South Carolina Building Codes Council

2021 MODIFICATION INDEX

*Modification Index numbers below are hyperlinked to the referenced modifications. The LLR logo on each modification page links back to index.

Code Section: Figure R307.1 Minimum Fixture Clearances

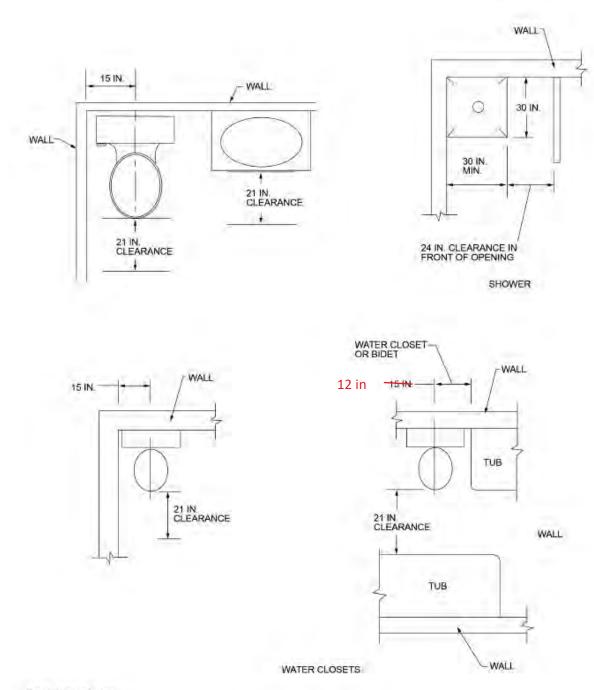
Change the minimum dimension for the side clearance between bathtub and water closet or bidet from 15 inches to 12 inches. See Figure on next page.
